Re: Presentation of Planning Commission's recommendation on the application of Victor and Michelle Gorsh of a Preliminary Plat for a six (6) lot residential Major Subdivision totaling 33 acres, more or less, known as MicVic Acres, part of the SE $\frac{1}{4}$ SW $\frac{1}{4}$ less the west seven (7) acres of Section 27 in Winfield Township

STAFF REPORT

PRELIMINARY PLAT
MicVic Acres
 TO SCOTT COUNTY, IA
 BEING A RE-PLAT OF PARCEL
 #032751008 (33.04 ACRES) AND
 #032751009 (0.795 ACRES) LOCATED IN
 PART OF THE SOUTHWEST QUARTER OF
 THE SOUTHWEST QUARTER, LESS THE
 WEST SEVEN ACRES, OF SECTION 27 OF
 TOWNSHIP 80 NORTH, RANGE 3 EAST OF
 THE 5TH PRINCIPAL MERIDIAN, SCOTT
 COUNTY, IOWA

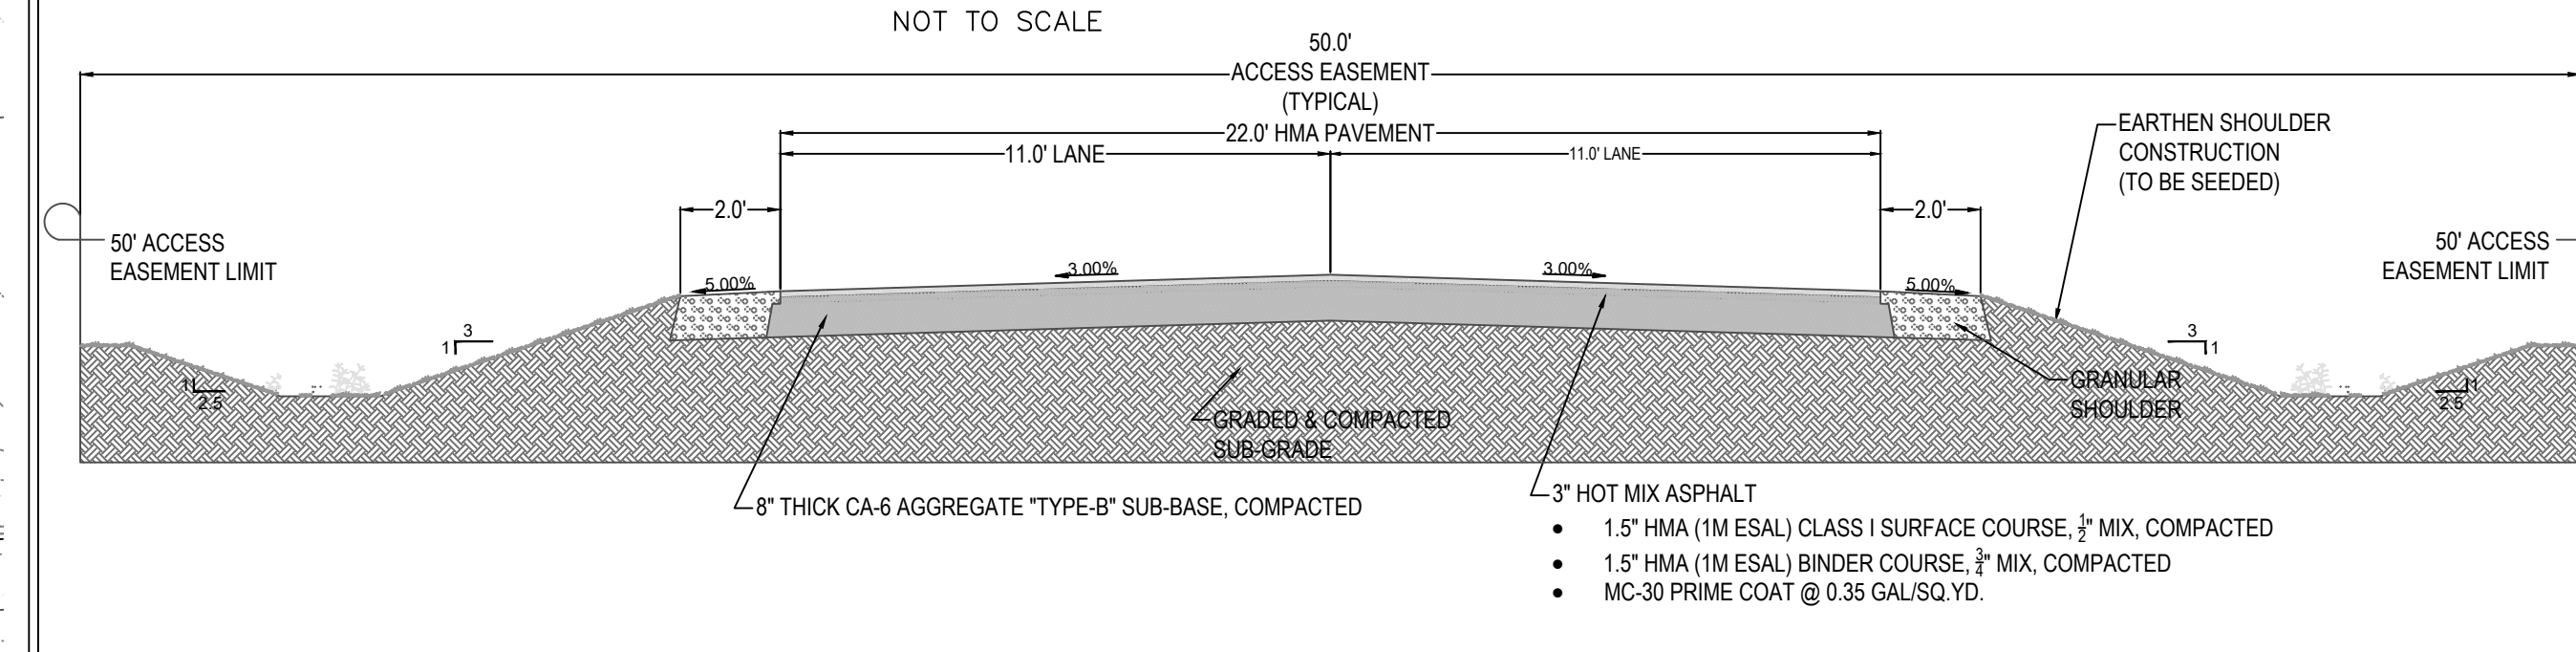
1. Are the lots (larger than 1 acre) intended to remain as is in the future or are there plans that they may be further subdivided into smaller lots? Section 20.01 of the Ordinance states if there are indications that the lots may be subdivided further, care needs to be made that the streets and lots are configured in a way that allows the further subdivision

2. 60 foot min width for streets – will this be dedicated to the City or is it going to only be a private road?
3. We would want a copy of the proposed subdivision restrictive covenants that address the shared road and other rules of the subdivision to review and approve

4. Section 28.08 – 10% setback of land or cash for Long Grove parks – needs to be addressed
5. Mason Creek – there appears to be a drainage easement on the plat map for it, but I cannot tell if there is at least 30 feet on each side that would be an easement granted to the City for purposes of maintaining, widening, or altering the stream, since it flows down to the City? – pursuant to 28.06.03

- Storm Water Detention Basins shall be located out of the 100year elevation of Mason Creek.
- Storm Water Detention Basin No. 1 shall be in an **outlot** too.

- Storm Water Basins shall be size to hold the 100 year storm with an 5 year existing release rate.
- Storm Water Basins calculations shall have Subbasins defined and Time of concentration paths define on a map attached to the calculations.

- Show how the runoff coefficients are calculated for the Storm Runoff Calculations?
- Provide Storm Water Basin No. 2 Stage/Discharge.
- Storm Water Basins shall have an emergency overflow that is armored.

- Shall meet City of Long Grove Standards on the following:
 - Pavement Width 31 feet back to back
 - Provide Sidewalks
 - Integral Curb & Gutter
 - Concrete Pavement

- Aggregate Subbase
 - Subdrains
 - Storm Sewer
 - 60 foot Street Right-of-Way instead of a 50' Access Easement
- Street shall be located out of 100 year elevation of Mason Creek

Storm water is being provided at Basin #2. It is also being provided at # Basin 1. (GENERAL NOTE 13.)

Basin #1 is on private lot #3. Basin #2 is on out lot A.

- Who will maintain these two basins?
- Do we need to have our Engineer check the Engineering on the storm water if the County is also doing it?

- The two lots to the west have been sold previously. Josh, is this a concern for the City that they are not included?
- All improvements shall meet Long Grove standard specs:
 - Do our specs require curb and gutter?
 - Width of the street?
 - Street Easement? Note this is a private street.
